REVIEW NOTES

ROCHESTER ER BRF 0162(18) – BRIDGE NO. 19

TEMPORARY ABUTMENT DRAWINGS

RE: Temporary Abutment Drawings received from Schultz Construction on 4/24/2014.

PLAN VIEW
1" = 20'

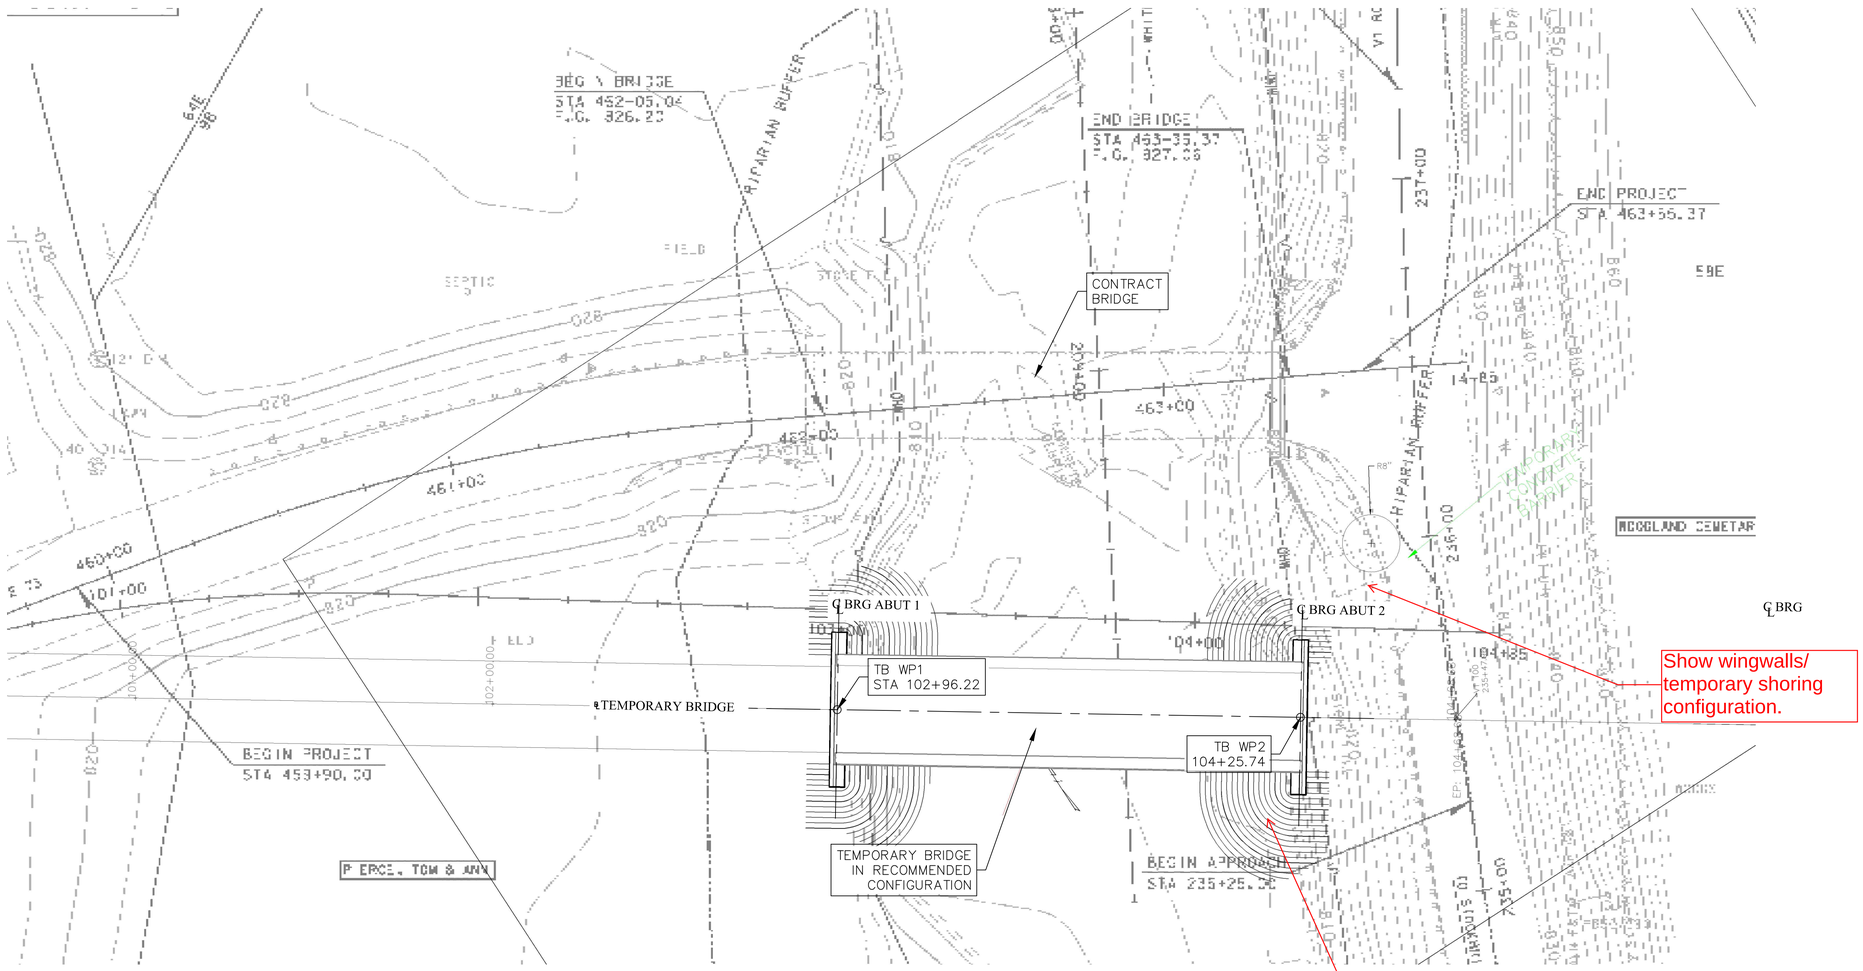
1. Show the contours and the toe of slope for the entire length of the detour.
2. See the following sheets for additional comments.

TEMPORARY BRIDGE PLAN VIEW

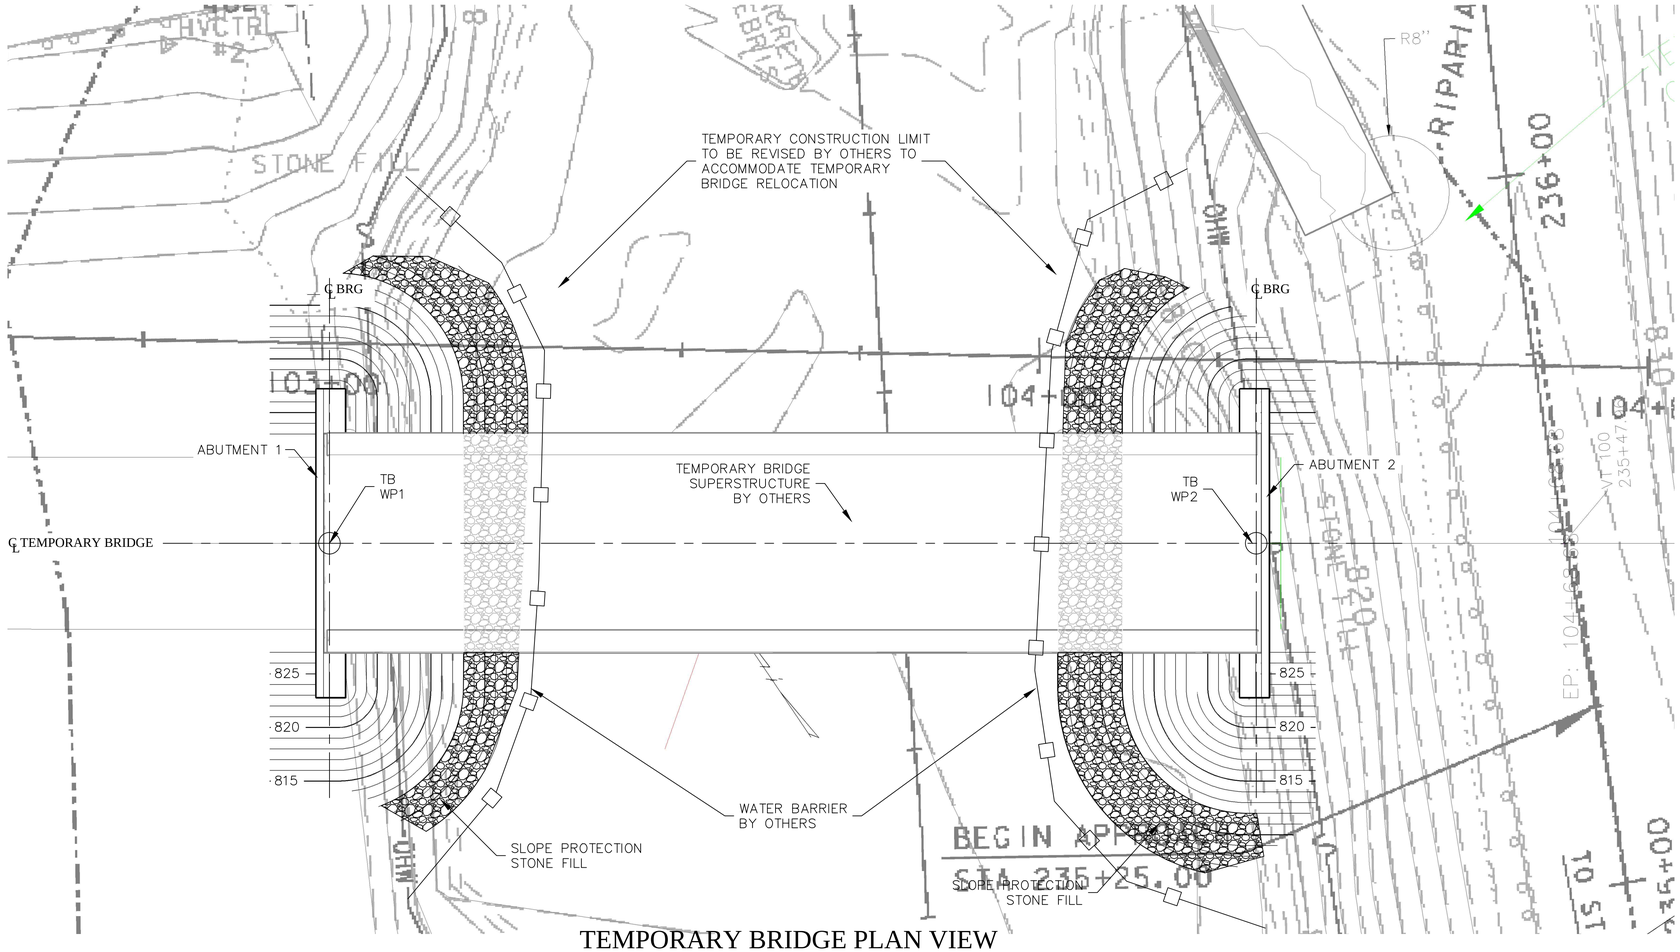
VTrans standard practice is to use 35 degrees for granular fill.

TEMPORARY BRIDGE ELEVATION

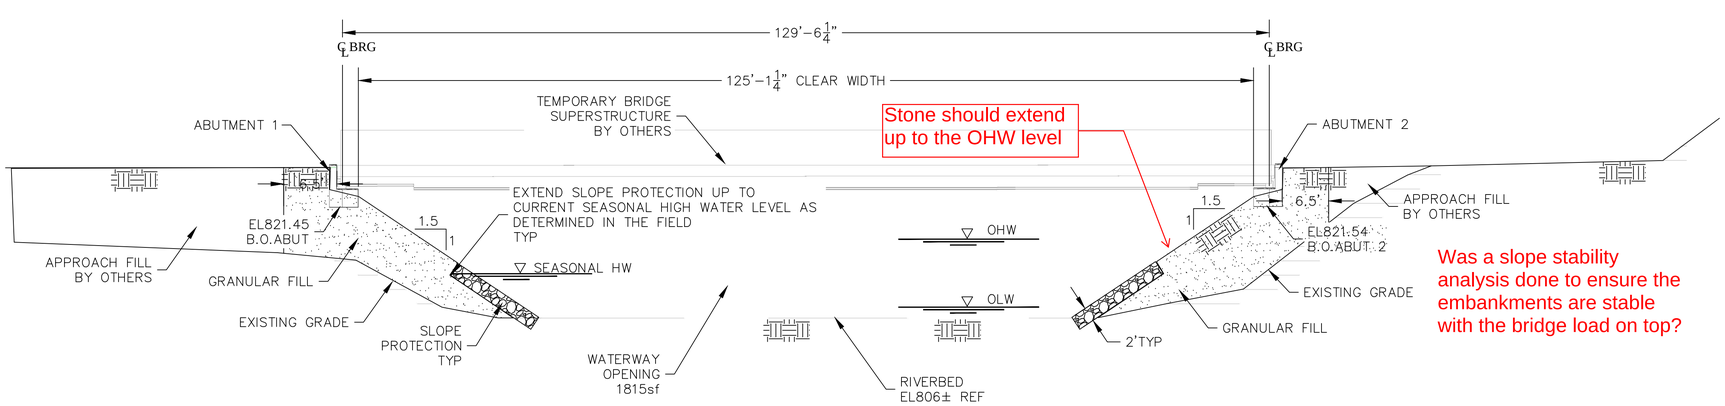
COMMENT:
2. On Bridge Elevation, label the vertical clearance above streambed and waterway area of full opening (waterway opening shall comply with requirements as shown on the Preliminary Information Sheet (sheet 175) in the Contract Plans).

The vertical clearance above streambed is a function of the temporary bridge superstructure span, slope, bearing elevations, cross section, deflection and sag and should, therefore, be determined established in the temporary bridge superstructure design. This substructure design document incorporates the bridge seat elevations dictated in the by the superstructure design document.

The clear span and waterway full opening have been added to the plan.

TEMPORARY BRIDGE ABUTMENT 2

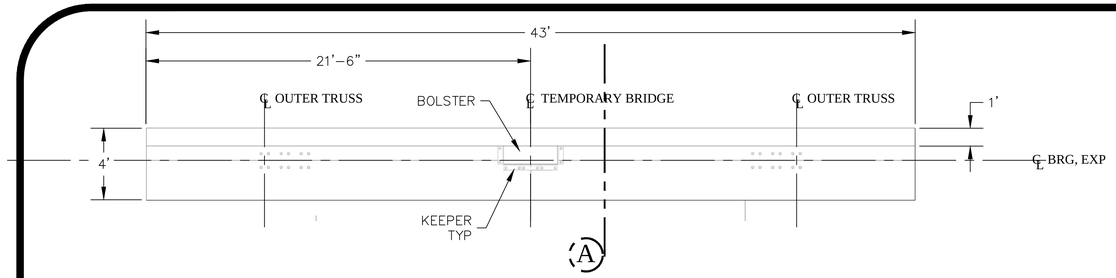
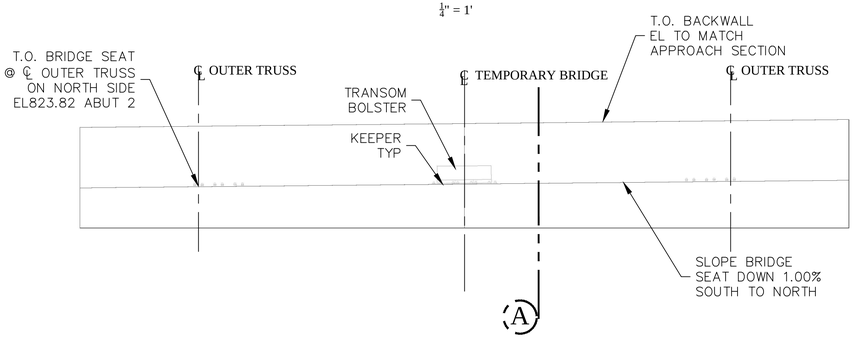
COMMENTS:
4. For temporary Bridge Abutment 2, verify that revised Abutment and Wingwall configuration allows for proper turning radius. A turning analysis was performed on the

revised temporary bridge layout as provided on March 7, 2014. The results of that analysis show that the turning movements worked marginally with the bridge configuration. The proposed abutment locations from this submittal are closer to VT 100. Please demonstrate that the turning movements work for the proposed abutment and wingwall configuration.

Further investigation by the GC and reviewing authority established a recommended temporary bridge configuration. The temporary bridge abutments have been relocated to accommodate the recommended configuration. The documents and drawings have been revised to reflect this change.
